COMMENTS TO THE AUTHOR:

amt-2020-517

This manuscript provides an evaluation of three noise-reduction algorithms for the “raw” equivalent black carbon (eBC) mass concentration data of the new 5-wavelength microAethelometer model MA200. This has been submitted for the special issue: New developments in atmospheric limb measurements: instruments, methods, and science applications (AMT/ACP inter-journal SI).

Figure R1 . The comparative measurements of the MicroAeth MA 200 with AE33.

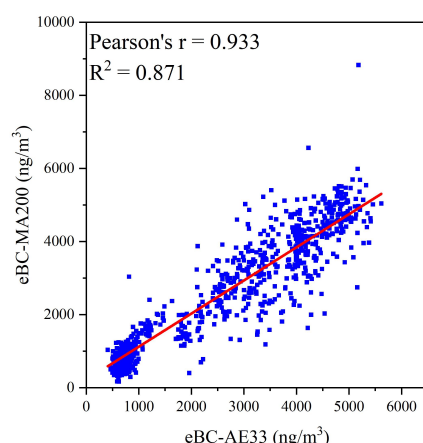
1. What methods were taken to account for the sensitivities of the instrument? The AE51 is known to be highly sensitive to vibrations, and sudden changes in the environment like RH and temperature. It is highly likely that the MA200 would have similar sensitivities, as also shown by Düsing et al. (2019) when it comes to strong RH variability. There was no detailed description on how the instrument was handled during the mobile measurements. This is vital since one of the criteria of the study is the retention of signals due to microenvironmental changes after noise reduction and identification of “peak samples”. It must be noted that the instrument may produce false peaks/signals (in either direction) as a result of vibration or sudden change in RH and T. This is even more significant given that very few or even data from only a single mobile measurement round was used in the analysis. Taking these sensitivities into account in the measurement itself, would strengthen arguments made on the retention of “peak signals/samples”.

Response: Thank you for your concern and suggestion. Firstly, the MA200's predecessor, the AE51 instrument, has shown some sensitivity to mechanical shock, relative humidity and temperature during mobile measurements. For mechanical shock, we have placed the MA200 in a carrying bag and secured it to a trolley, thus preventing mechanical shock during mobile sampling. For the sensitivity of the MA200 to relative humidity and temperature, the comparative measurements of the MA200 and the stationary Aethalometer (AE33, Magee Scientific, Berkeley, USA) showed good agreement between stationary measurements taken during each walk. Briefly, the AE33 was used to monitor black carbon at the same time as the MA200, following that, the AE33 was placed in a container (fixed monitoring site) while the MA200 was used outdoors (in a stroller) while walking alone with different relative humidity and temperature. This phenomenon had no effect on the accuracy of the black carbon concentration for either instrument (Pearson's $r = 0.933$, below figure). The brief description about mechanical shock, relative humidity and temperature has been added in the revised manuscript. Please refer to line 140-147 and 383-396 for further confirmation.

RH and Temperature: The following text has been added to section 2.1:

In addition, it is worth noting that when the AE33 was used for monitoring black carbon at the same time as the MA200, the AE33 was placed in container, while MA200 was used outdoor (in the stroller) during the individual walks, which may have different relative humidity and temperature. This

phenomenon did not influence the consistency of eBC concentration measured with both instruments.
